ACCESSION NUMBER: 8111190667 DOC. DATE: 81/11/10 NOTARIZED: NO DOCKET #
 FACIL: 50-389 St. Lucie Plant, Unit 2, Florida Power & Light Co. 05000389
 AUTH. NAME: UHRIG, R. E. AUTHORITY AFFILIATION: Florida Power & Light Co.
 RECIP. NAME: EISENHUT, D. E. RECIPIENT AFFILIATION: Division of Licensing

SUBJECT: Forwards responses to NRC request for addl info re battery capacity & load shedding, during station blackout. Responses will be incorporated into future amend to FSAR.

Re: St. Lucie Unit 2
Docket No. 50-389
Final Safety Analysis Report
Requests For Additional Information

Attachment to L-81-474
November 10, 1981

FIG. 1

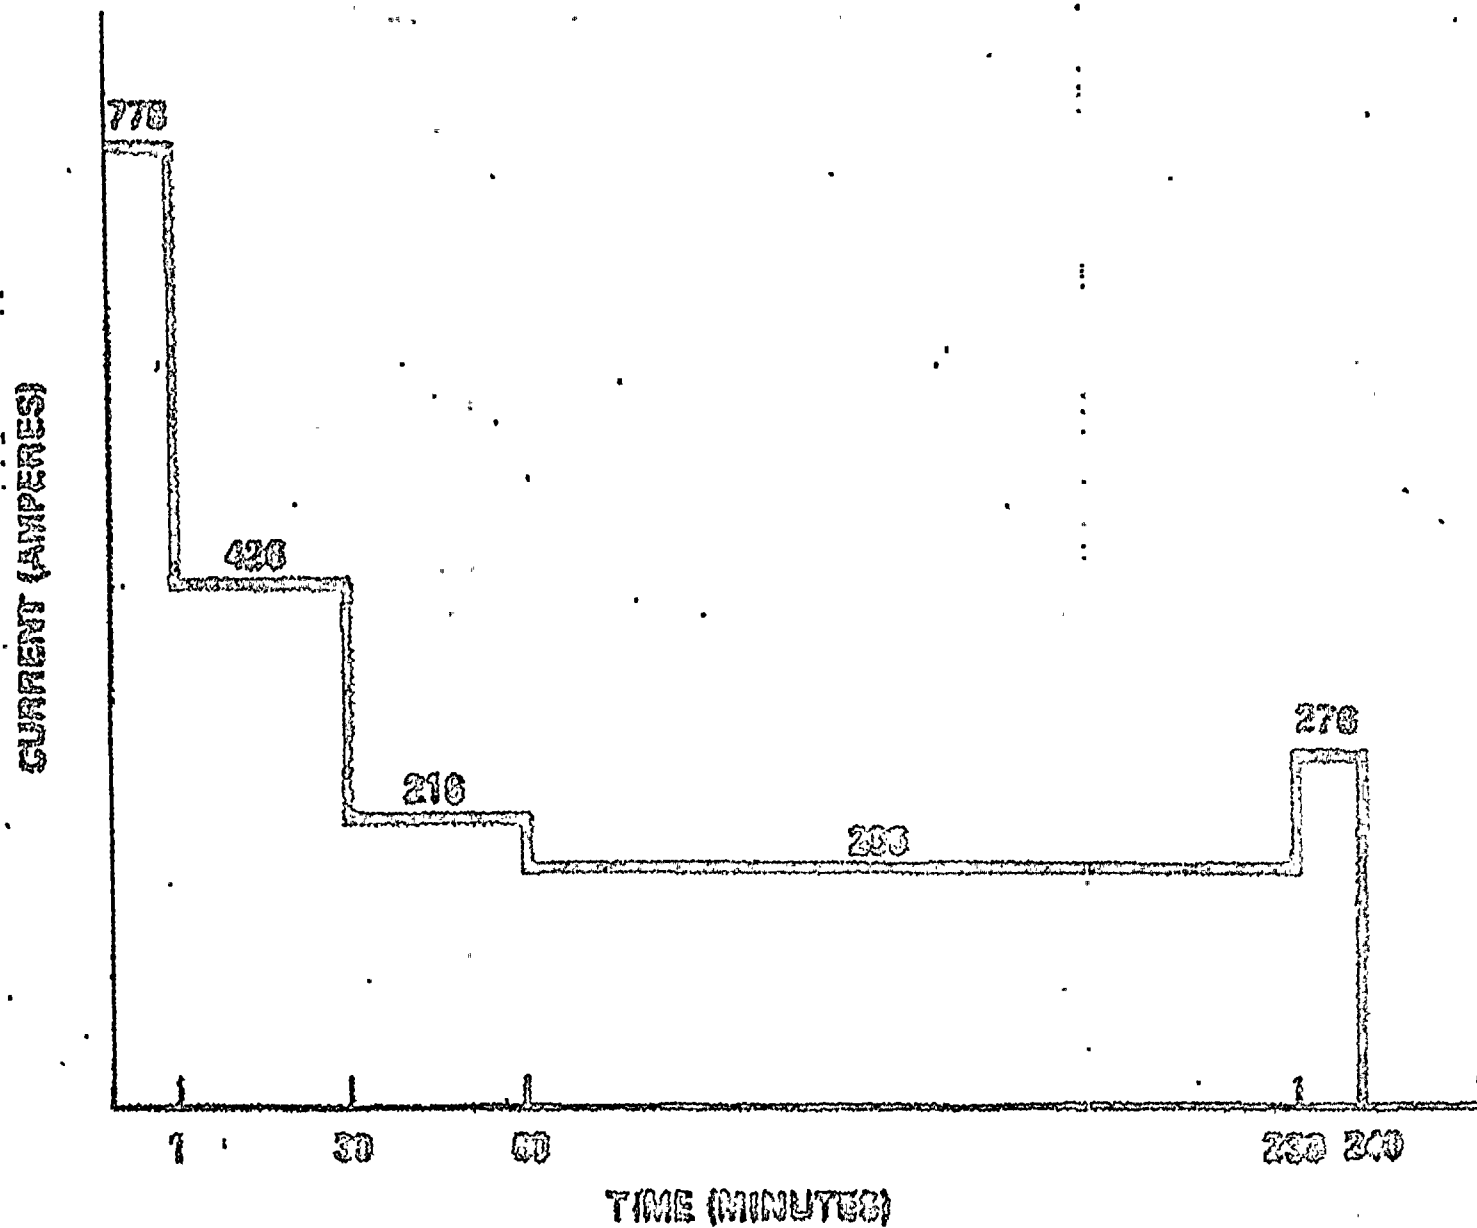
Response: NRC request for additional clarification of battery capacity and load shedding during the station blackout event.

To assure that sufficient battery capacity exists to accommodate the station blackout event an iterative set of battery load profile calculations were performed. The acceptable load profile which encompasses the conservatively defined event duration of four hours was obtained and is shown in Figure 1.

The load profile was developed and based on the most heavily loaded DC bus, 2B, and includes loads on the swing bus 2AB. (Calculations assure the AB bus is being supplied from the 2B bus). The assumption is made that no operator action occurs in the first 30 minutes of the event, as reflected in the load profile.

Thirty minutes into the event the operators secure power to selected DC loads, listed in Table 1, which reduces the load on the battery, as reflected in the load profile. At three hours and fifty-nine minutes into the event the operator flashes the diesel generator field in accordance with IEE 485, "Recommended practices for sizing large lead storage batteries for generating stations and substations". A standard calculation utilizing the Hoxie methodology was performed to demonstrate that the battery capacity was sufficient to support the defined load profile.

Figure - 1

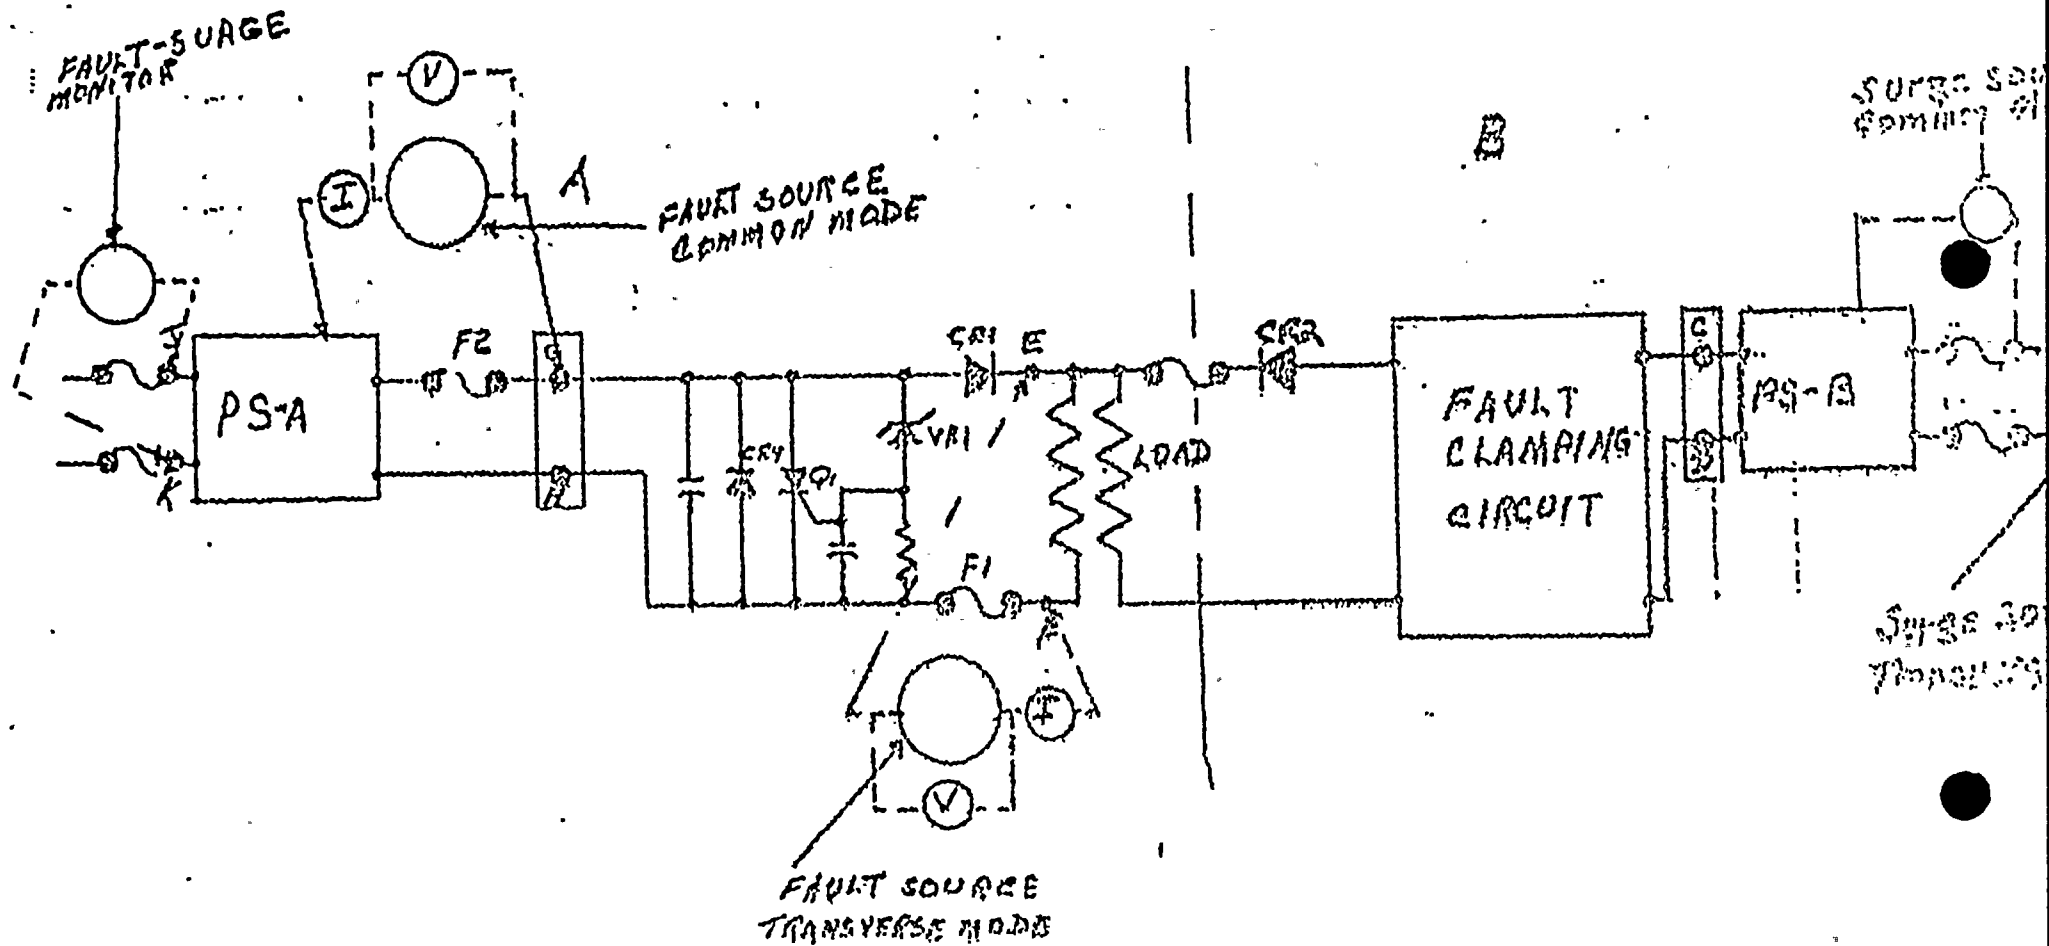
For the purpose of this test, it has been conservatively assumed that if a fault appeared on vital bus B (points A or B to chassis ground in Figure 1) it

would propagate through the DC power supply (PS-B) and appear at points C or D. Since PS-B is directly connected to PS-A (through CR-1 and CR-2) the fault is assumed to appear at points G or H to ground. Therefore, it is required to show that when a fault is present on the DC side of a matrix power supply it does not propagate to the 120 Vac side of the power supply, thereby affecting more than one vital bus. It should be noted that complete propagation of a fault from power supply primary to secondary is a conservative fault circuit evaluation which would most likely not occur.

Similar to the common mode test, a fault appearing on vital bus B (Figure 1 points A and B) is assumed to propagate completely to points E and F. Therefore, it must be shown that application of a fault to the output of the isolation circuit (points E and F) does not propagate in the 120 Vac side of power supply A thereby affecting more than one vital bus. It should be noted that the isolation circuit clamps the fault voltage such that power supply damage does not occur, as discussed below:

Clamp Circuit - The power supply fault clamp circuit is designed to limit or shortout a positive or negative fault. Figure 1 is a schematic of the fault clamp circuit which is connected to each matrix power supply. During normal operation VRI is in the open circuit condition, SCR-Q1 is deenergized and CR4 is reverse biased. The normal 28 Vdc output of the power supply will be seen between points E and F.

The clamp circuit operates in the following manner. On the negative cycle, the fault is clamped or shorted out by CR4, causing F1 to open. On a positive cycle, the fault would cause VR1 to conduct upon reaching an amplitude to 47V (combined 28V PS volts and 19V fault).

With VRI conducting, SCR-Q1 will energize, shorting out or clamping the fault and the power supply output, causing F1 and F2 to open.

Figure -2.

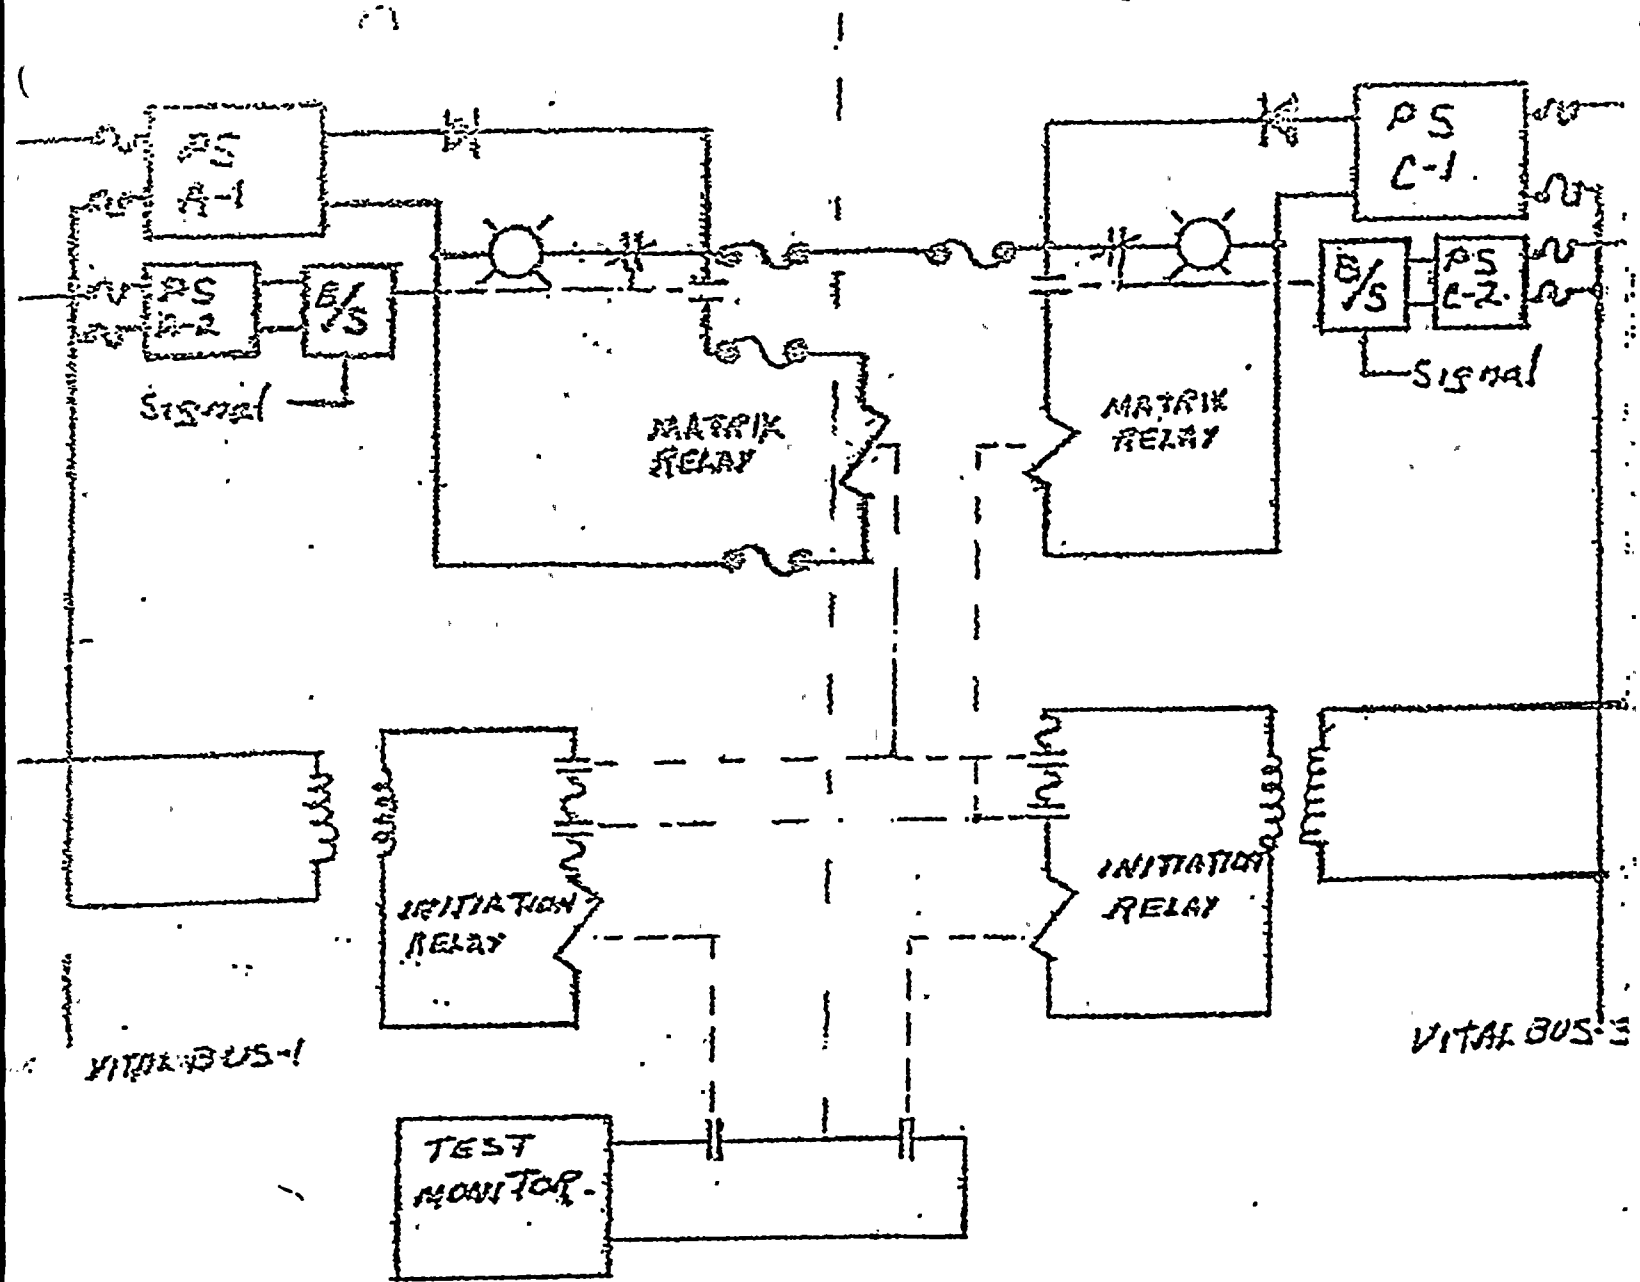
Matrix power supplies and isolation circuits are configured within the RPS as shown in Figure 1. The test involves simulating (with identical equipment) a typical RPS matrix (Figure 2) including bistable trip units, bistable power supplies, matrix power supplies, matrix relays, and isolation relays. Vital bus power (120 Vac) is simulated by using two power isolation transformers. The isolation test will consist of the application of a 600 Vac and 400 vdc fault in the circuit in the common and transverse modes. The basis for the 600 vac and the 400 Vdc test voltage is as follows:

The test involves simulating (with identical equipment) a typical RPS matrix (Figure 2) including bistable trip units, bistable power supplies, matrix power supplies, matrix relays, and isolation relays. Vital bus power (120 Vac) is simulated by using two power isolation transformers. A 300 Vac surge (negative peak to positive peak) will then be superimposed on one vital bus. Thus, the test voltage from neutral to peak will be 337 volts (120 Vac + 10%) x 1.414 plus the neutral to peak surge 300V/2. The surge voltage is based on a calculation performed for the ANO-2 PPS which concluded that circuit damage or false operation would not occur provided the peak AC voltage is maintained below 400 Vac. The calculation is based on dielectric strength of materials within the ANO-2 PPS. Since the equipment within the St. Lucie Unit 2 PPS is similar (but not identical) to the ANO-2 PPS it is assumed that calculation conclusions are applicable to the RPS.
